NRC RAI Letter No. PTN-RAI-LTR-041

SRP Section: 02.05.01 - Basic Geologic and Seismic Information

NRC RAI Number: 02.05.01-8 (eRAI 6024)

Proposed Turkey Point Units 6 and 7
Docket Nos. 52-040 and 52-041
FPL Revised Response to NRC RAI No. 02.05.01-8 (eRAI 6024)
L-2013-236 Attachment 8 Page 3 of 4

Figure 2.5.1-229 Regional Tectonic Features

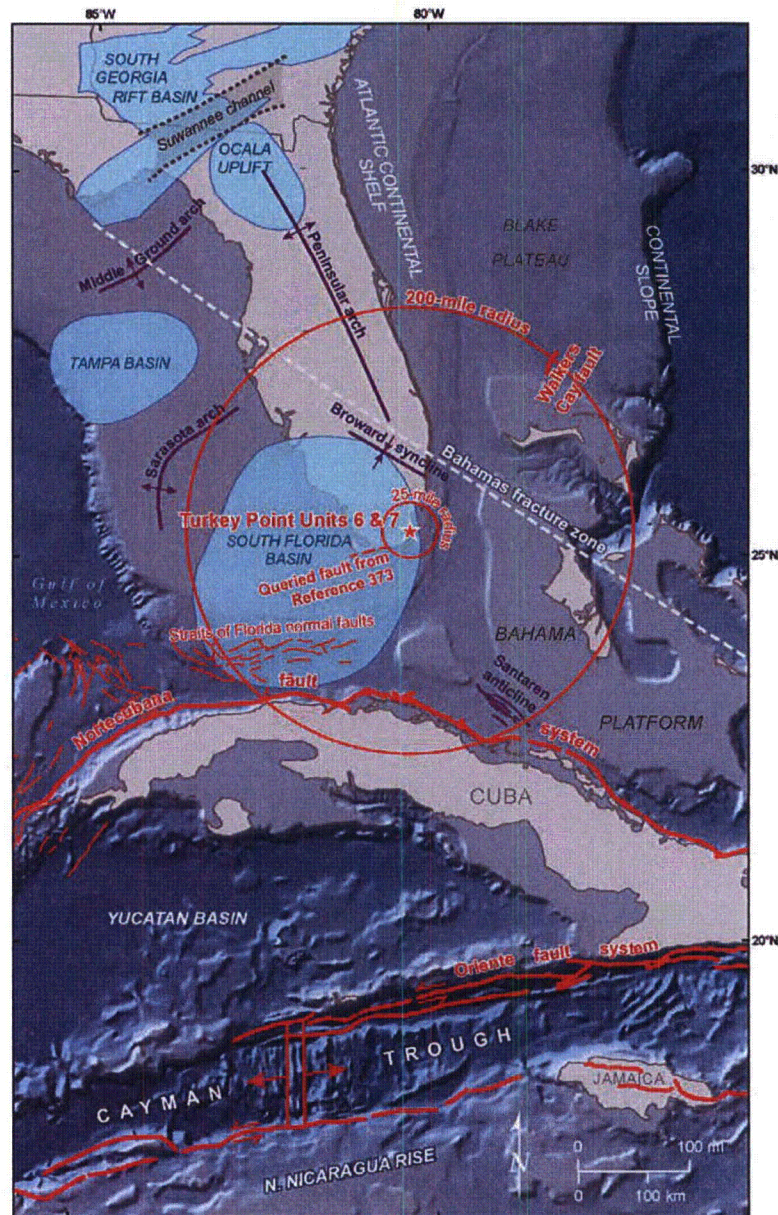
As described in FSAR Subsection 2.5.1.1.1.3.2.2 and RAI Response 2.5.1-16, the Straits of Florida normal faults were primarily active in the Eocene and acted to thin the overthickened wedge of foreland material shed off the colliding Greater Antilles arc (FSAR References 2.5.1-221 and 2.5.1-482) (FSAR Figure 2.5.1-229). These structures were active in the Eocene and show very little evidence for younger deformation (Figure 2.5.1-209) though some may have been reactivated in response to far-field effects of collision in

FSAR Figure 2.5.1-229 will be revised in a future COLA revision to include a label for the Straits of Florida normal faults as shown below:

Figure 1. Figure 5 from Cunningham et al (1998); Stratigraphic correlation diagram across southern Florida.

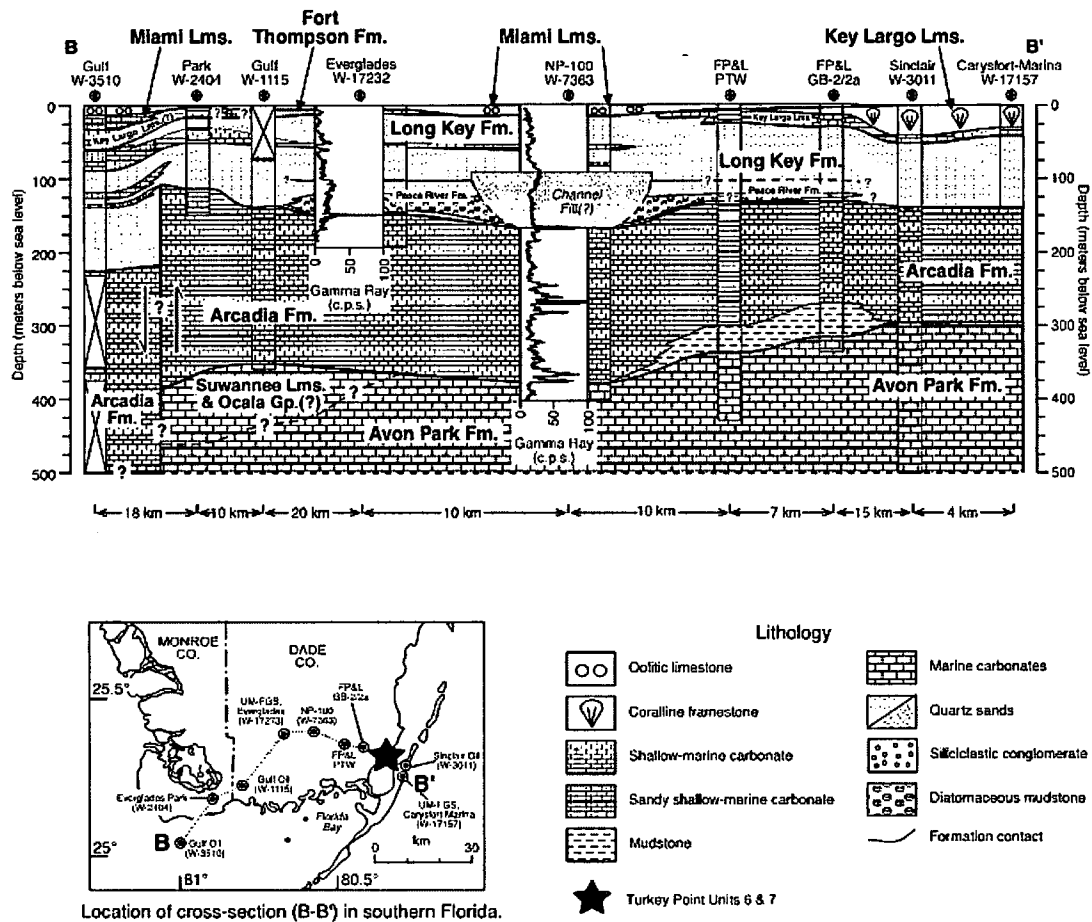
- a) Substantiate your interpretation with specific evidence that the stratigraphic relations across the queried fault shown in Figure 2.5.1-234 and depicted in Reference 373 are a result of paleo-topographic or karst processes, rather than tectonic offset.
- b) If the queried fault is indeed a fault, please discuss the timing and spatial extent of faulting and update the FSAR discussion accordingly.

a) Substantiate your interpretation with specific evidence that the stratigraphic relations across the queried fault shown in Figure 2.5.1-234 and depicted in Reference 373 are a result of paleo-topographic or karst processes, rather than tectonic offset.

Figure 1 is a modified version of FSAR Figure 2.5.1-234 that shows a cross-section across southern Florida (Figure 5 of Cunningham et al. [1998]). This cross-section was developed with data from eight wells in southern Florida. Between the southernmost two wells, Cunningham et al. (1998) postulate the existence of a fault that cuts up through Avon Park Formation, Suwannee Limestone, and Oligocene-Miocene-age Arcadia Formation, and potentially places the Arcadia Formation in fault contact with the lower portion of the overlying Miocene-Pliocene Long Key Formation. Alternatively, the Long Key Formation may be interpreted as deposited across a paleoscarp. Cunningham et al. (1998) label the postulated fault on this cross-section with two question marks,

indicating the speculative nature of this fault. It should also be noted that Figure 1 includes a variable horizontal scale, which necessarily results in variable vertical exaggeration throughout the cross section. Some of the greatest vertical exaggeration is in the vicinity of the postulated fault.

The queried fault on Cunningham et al.’s (1998) Figure 5 (FSAR Figure 2.5.1-234) is drawn to explain thickness and stratigraphic variations. These variations may instead be related to paleotopography, indeed, the top of the Arcadia Formation is known to have significant paleotopographic variation. On Key Largo, relief on the top of the Arcadia Formation as large as 40 meters was found between borings only a few kilometers apart (Warzeski et al., 1996). Furthermore, in Cunningham et al.’s (1998) Figure 4 (Figure 4), the elevation of the top of the Arcadia Formation varies by approximately 100 meters between wells W-3174 and W-17086 (88 km apart), by 50 meters between wells W-17156 and W12554 (56 km apart), and by 25 m between wells W-3011 and W-17157 (2 km apart). The slope required to achieve this latter elevation variation, 0.7 degrees, is actually greater than the slope required to achieve the elevation variation observed in the Arcadia Formation between the Everglades Park and Gulf Oil wells, where the queried fault is depicted in Figure 5 of Cunningham et al. (1998) (approximately 100 meters over 18 kilometers of distance, or a 0.3 degree slope). Numerous other examples exist throughout southern Florida of steeper paleotopographic slopes on the top of the Arcadia Formation that are not associated with faulting. In addition, the down-to-the-south separation depicted on the postulated fault in Figure 1 is consistent with, and may, in part, be attributed to the regional southward dip of the strata towards the South Florida Basin in the area (e.g., Miller, 1986; Figure 6). Similarly, the increase in the thickness of clastics south of the fault is consistent with thickness variations seen throughout southern Florida associated with proximity to the “coarse sand channel” (Figure 2).

Cunningham et al. (1998) provide no discussion of the age of most-recent slip on their postulated fault. Based on the depiction of the queried fault in Figure 5 of Cunningham et al. (1998), the fault tips out at the base of the Arcadia Formation and the Arcadia formation is potentially in fault contact with the lower portion of the overlying Miocene-Pliocene Long Key Formation (Figure 1). The depiction of potentially folded strata within the Long Key Formation (Figure 1) could be interpreted to suggest syntectonic deposition. Thus, one could interpret that movement on the postulated fault is as young as Miocene-Pliocene.

Figure 2.5.1-229 Regional Tectonic Features

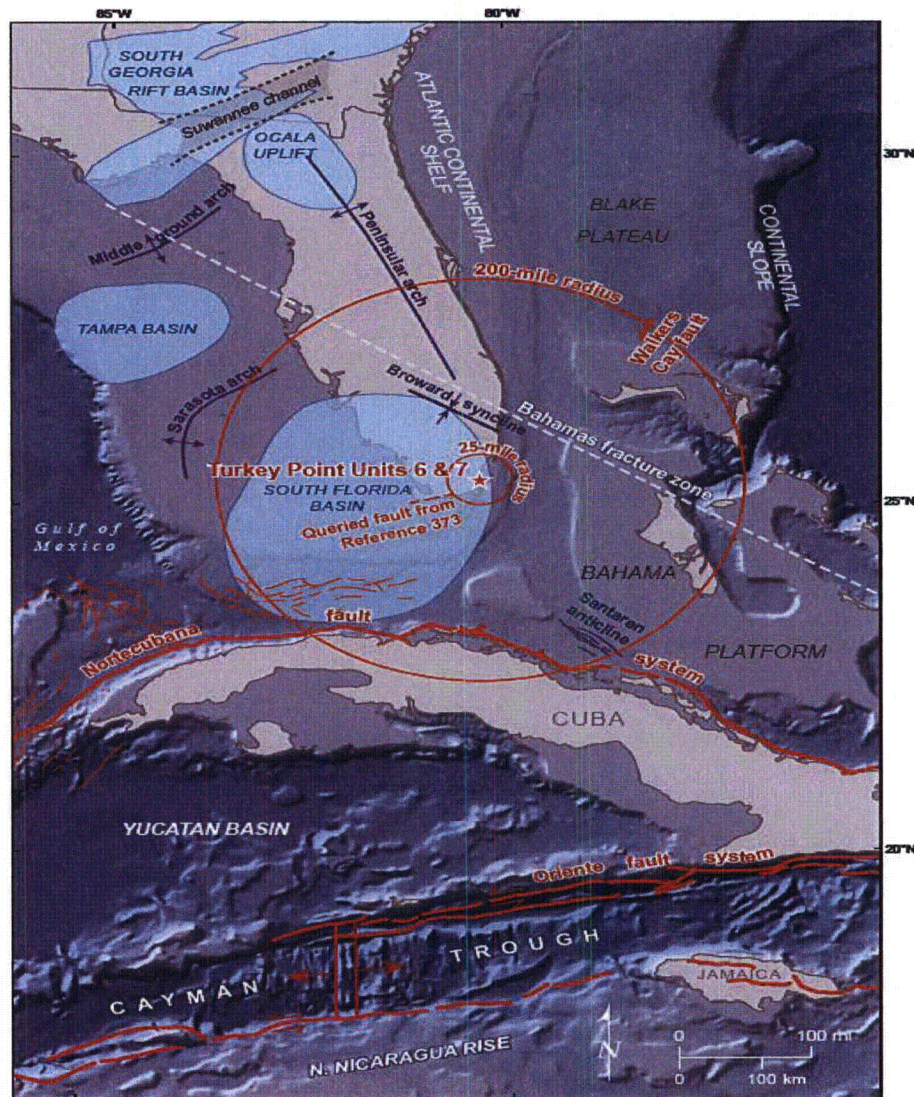
Cunningham et al. (Reference 373) postulate that a fault or paleotopography could be responsible for elevation variations in the Arcadia formation in southwestern Florida (Figure 2.5.1-229). The queried structure is between 50 and 60 kilometers long (30 - 36 miles) (Figure 2.5.1-229) and at its nearest approach, the eastern end of

The following figure will be revised in a future COLA revision:

Figure 2.5.1-381 Structure Contour Map of the Top of the Oligocene-Miocene Arcadia Formation

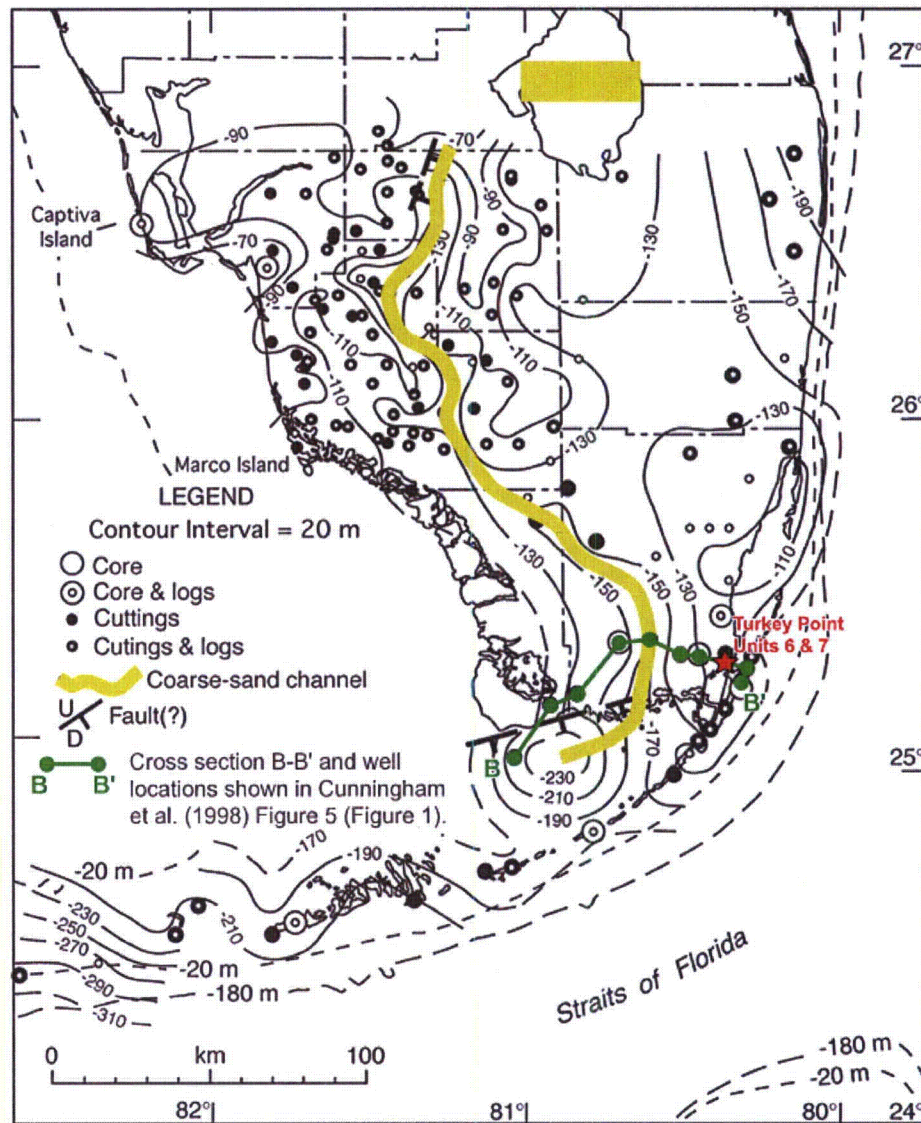
As shown in Figure 2.5.1-351, there are three wells adjacent to the queried structure: Gulf Oil W-3510 south of the postulated fault and W-1115 and W-2404 north of it. The Gulf Oil well W-3510 appears to control the set of structure contours used to delineate the area of faulting (Figures 2.5.1-234 and 351). Yet, other published contour maps of the same well data use dashed contours and question marks to indicate uncertainty in contouring such sparse data in the Florida Bay area (Reference 393). A later publication (Reference 935) also provides interpretations of unfaulted Miocene to Pliocene stratigraphy in the same location as the postulated fault from Reference 273.

The following new figure will be included in FSAR Subsection 2.5.1 in a future COLA revision:

Figure 1 Comparison of mapped depictions of the Walkers Cay fault based on seismic reflection data (modified from Van Buren and Mullins's (1983) (FSAR 2.5.1 Reference 791) Figures 2 and 13, and Austin et al.'s (1988b) (FSAR 2.5.1 Reference 785) Figures 3 and 9.

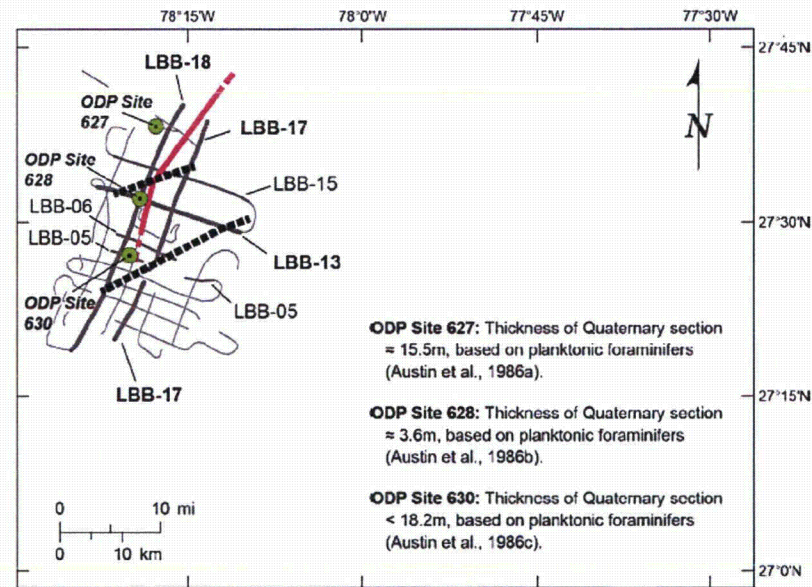
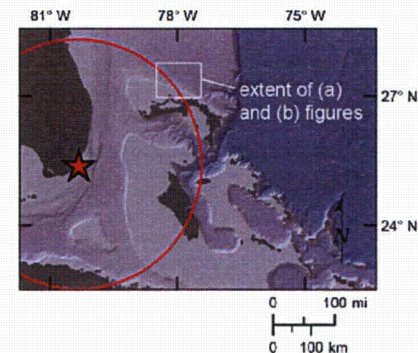
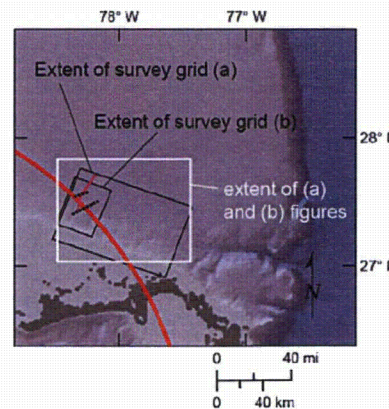
- 1) Label Walkers Cay fault on FSAR Figure 2.5.1-276.
- 2) Explain the basis for Harwood and Towers (1988) conclusion within the limits of resolution for marine seismic reflection data.

of any individual strands within the zone. These boundaries of the Walkers Cay fault zone are defined as having a more easterly strike than the fault of Van Buren and Mullins (1983) (FSAR 2.5.1 Reference 791) and a similar length (Figure 1). The spatial coincidence of the faulting expressed in Oligocene- to Cretaceous-age strata with a magnetic anomaly has been used to interpret the Walkers Cay fault as a basement-involved structure (Mullins and Van Buren 1981; Sheridan et al. 1988) (FSAR 2.5.1 References 474 and 307).

Figure 2.5.1-276 Seismic Line and Interpretation Across the Walkers Cay Fault

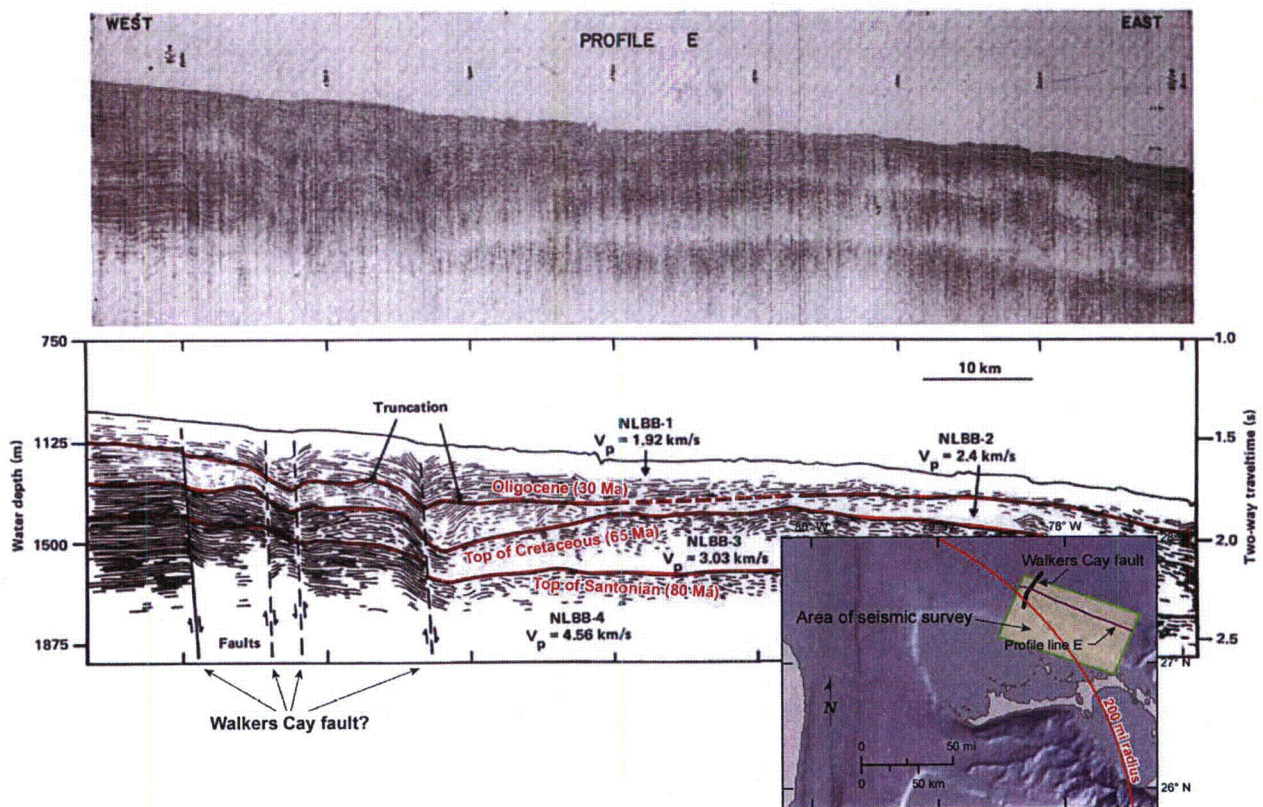
1) Label Walkers Cay fault on FSAR Figure 2.5.1-276.

FSAR Figure 2.5.1-276 is revised to label the fault strands that compose the Walkers Cay fault. Revised FSAR Figure 2.5.1-276 is provided in the Associated COLA Revisions section of this response.

FSAR Figure 2.5.1-276 will be replaced with the following revised figure in a future revision of the FSAR:

Figure 2.5.1-350 Regional Seismicity Plotted on a Map of the Nortecubana Fault and Santaren Anticline

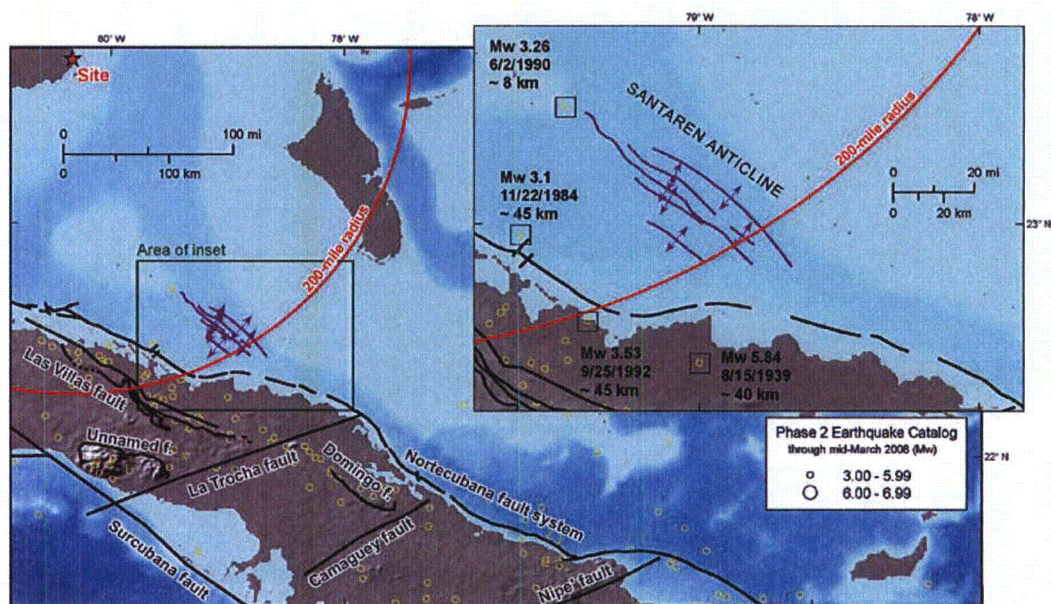
The Santaren anticline and the Nortecubana fault system are discussed in FSAR Subsections 2.5.1.1.1.3.2.2 and 2.5.1.1.1.3.2.4 as being spatially and temporally associated with the northern reaches of the Cuban orogeny, and, as such, it is likely they were genetically associated with similar convergent plate boundary driving forces. Additionally, the Santaren anticline appears to be on trend with the eastern portion of the Nortecubana fault (Figure 3). The fact that there is no detailed mapping for the

Figure 3 will be added as a new FSAR figure in a future COLA revision as Figure 2.5.1-350.
